## Consistency Assessment Approval Form

SSI\_7400 Sydney Metro Chatswood to Sydenham

### **Martin Place Demolition Haul Route – see Figure 1**

Figure 8-34 Martin Place Station haul routes  
**Figure 2 Red line showing the new haulage route, Bent and Bligh Street**

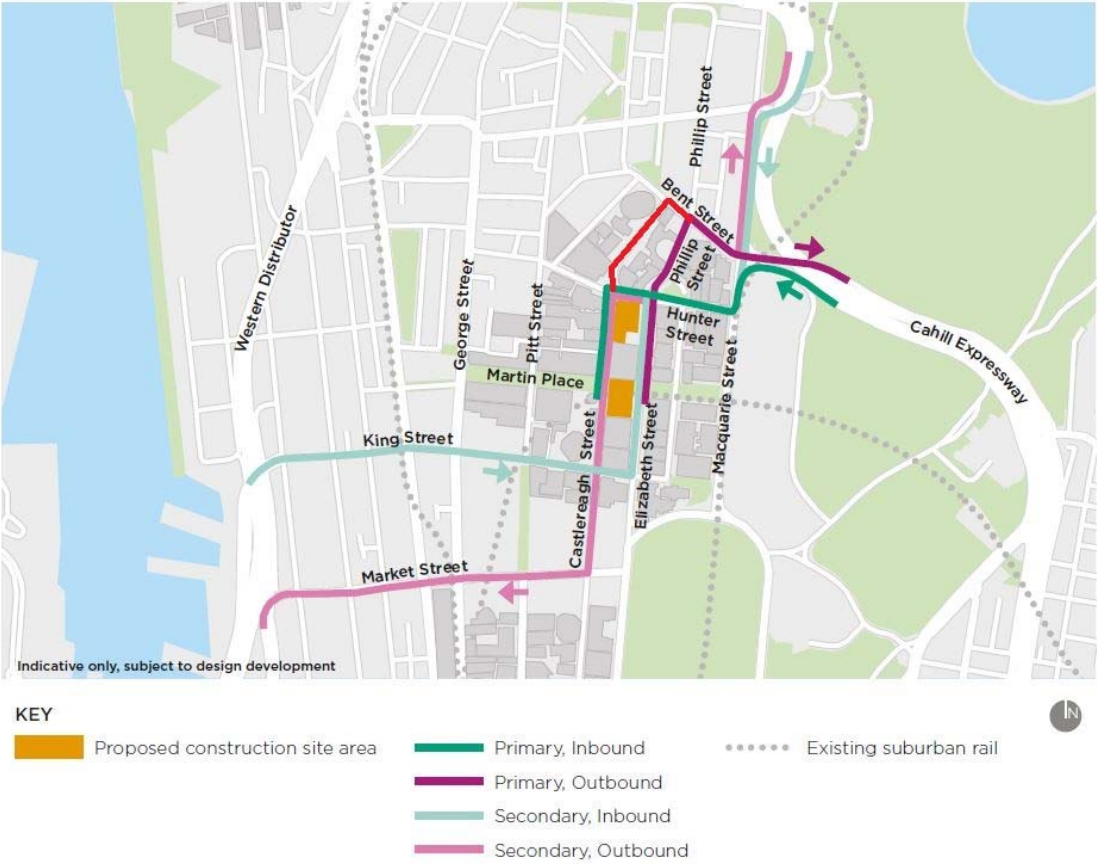
The proposed Metropolitan demolition haul route for Martin Place sites has deviated from the approved EIS route in one location that is a 45m section of Bent Street and the length of Bligh Street (150m). See Figure 2.

A change to the haul routes for the demolition of Martin Place sites has been proposed by Metropolitan. The change introduces a small section of Bent St and Blight Street to the alignment.

City of Sydney Council suggested the following change to the approved haul route *“Amend “From East: Trucks will approach the site from William Street. right into Palmer Street. Right into Sir John Young Crescent and Shakespeare Place, straight into Bent Street, left into Bligh Street, continue into Castlereagh Street and turn left into the site.”*

Additionally Sydney Coordination Office advised TTPP that *“the preferred inbound haulage route between Eastern Distributor and the Martin Place site is to be via Bent Street instead of Macquarie Street. The Sydney Coordination Office requested construction vehicles to approach to the demolition site via Bent Street to avoid the congested right turn movement from Macquarie Street into Hunter Street.”*
